Application Number: CCC/22/151/FUL

For: Construction and operation of thermal treatment facility for the generation of electricity from non-hazardous, residual waste (post-recycling); including associated plant and infrastructure, vehicular access, car parking and landscaping

To: Planning Committee

Recommendation: That permission is **refused** for the reasons set out in paragraph 24.1 .

#### Viewpoint 5 – September 2022

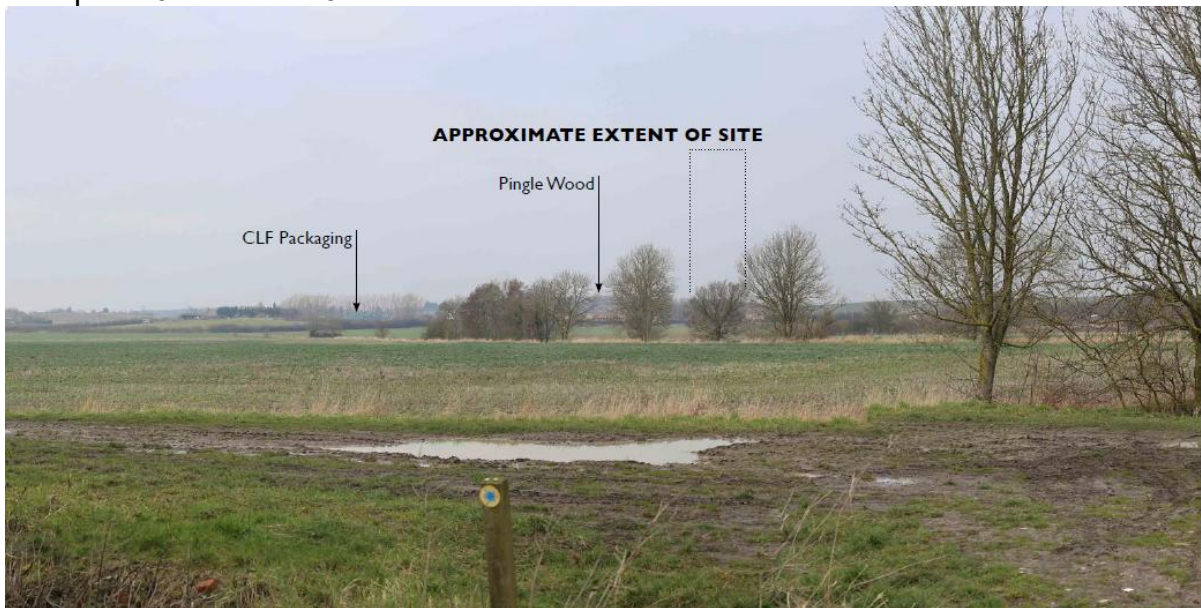
Construction: Taller plant may be visible. Magnitude of change: low. Construction effects: slight / negligible adverse.

Operation: The development would be mostly screened from this location due to local vegetation and built form. The top of the boiler building (20 metres with a base around 8 metres AOD giving a total height of 28 metres AOD) would not be visible over the ridge, which rises to a maximum of 32 metres AOD. Existing vegetation between the viewer and the Site would add screening but the 44 metre stack would still be visible, but its thin form would make it difficult to distinguish from other man-made structures. Magnitude of change: negligible. Operational effects: negligible.

Viewpoint 7 – Sept 2022

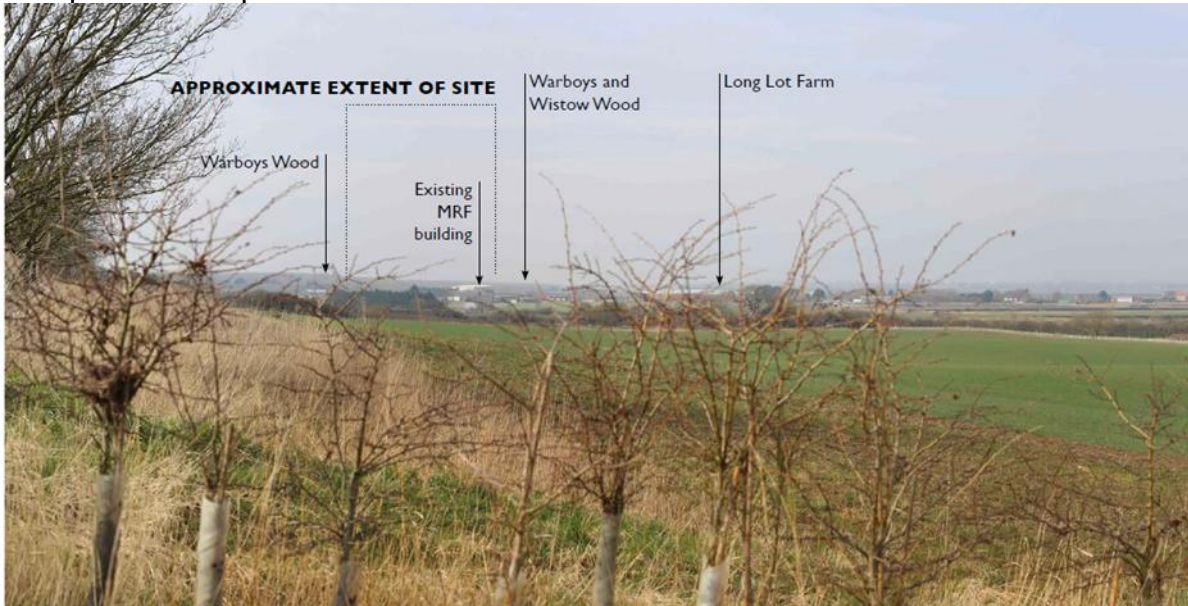
- 10.33 Landscape consultant comment: The sensitivity of receptors at this viewpoint should be high because it is on a long-distance walking route.
- 10.34 Viewpoint 7 - Warboys Footpath 8 near Woolvey Farm approximately 2 km east of the Site representative of public rights of way users. The view is elevated overlooking a wide expanse of the Fens. The MRF building, agricultural buildings and windfarms can be seen. Visual sensitivity: medium.

Construction: Vehicle movements will be noticeable, but at this distance would look similar to agricultural or existing traffic associated with the recycling facility. Magnitude of change: negligible. Construction effects: negligible.

### Viewpoint 9 - Puddock Road, near Lant's Farm March 2022

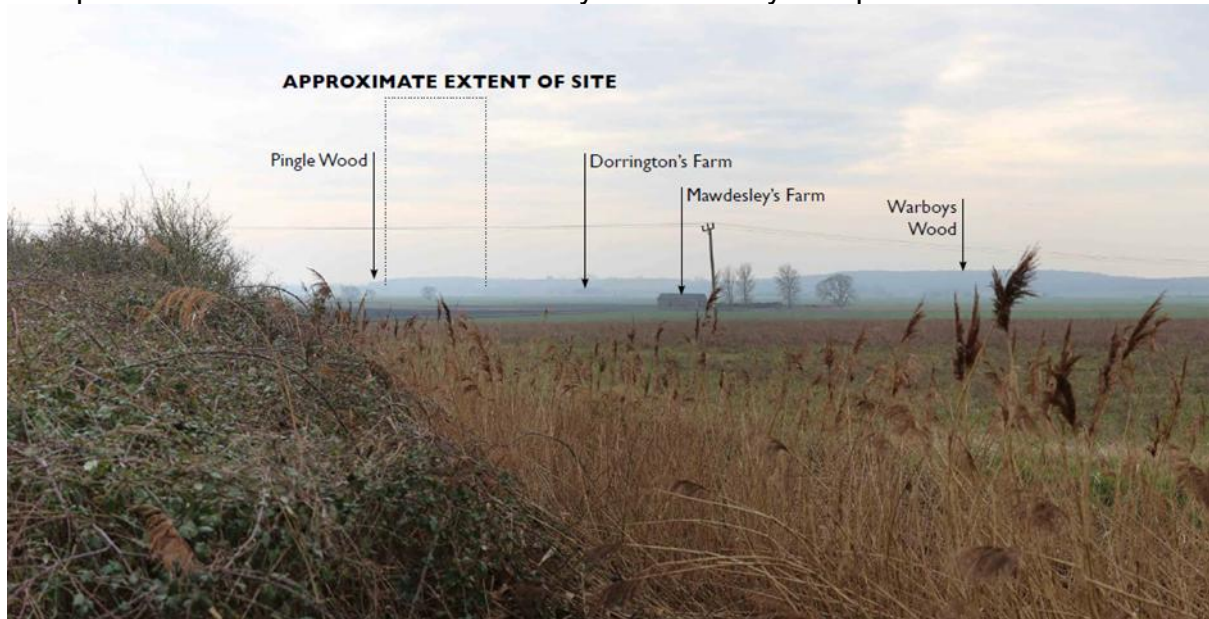
Construction: Difficult to see at this distance amongst buildings and vegetation. Magnitude of change: negligible. Construction effects: negligible.

Operation: The change in view will be very slight. Colour choice will help reduce the development's visual prominence, even at considerable distance. The stack will break the skyline but at this distance and in the context of the whole view would draw little attention to the development. The plume would not be visible. Magnitude of change: negligible. Operational effects: negligible.

Viewpoint 11 – Pathfinder Long Distance Walk northern edge of former airfield  
March 2022

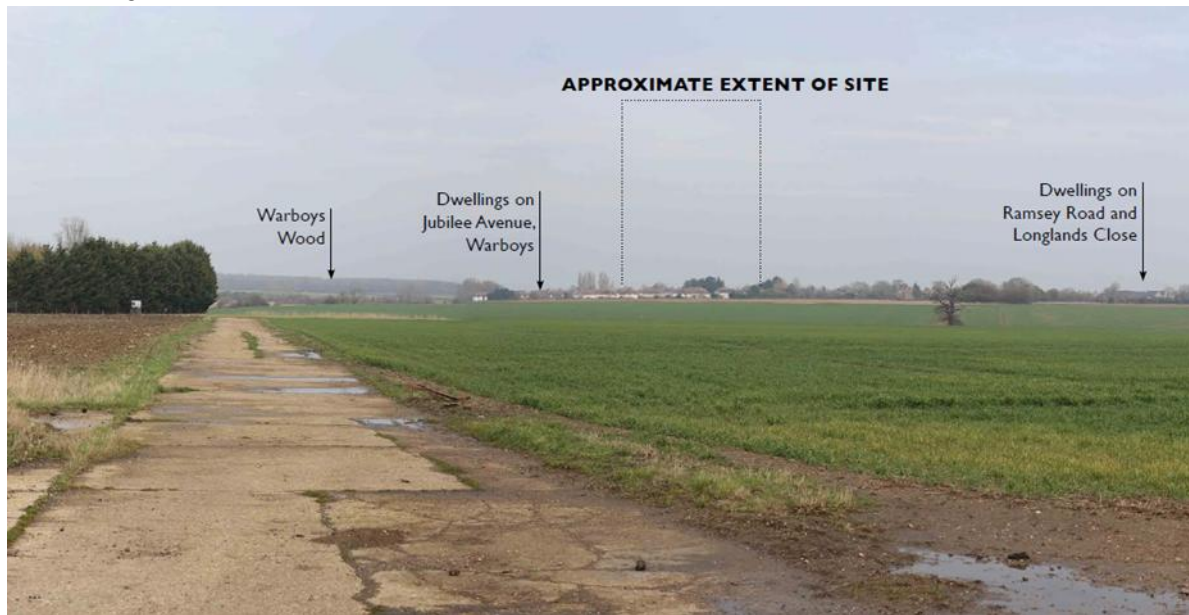
Construction: No change in view. The Site is screened by trees and dwellings in Warboys. Magnitude of change: none Construction effects: none
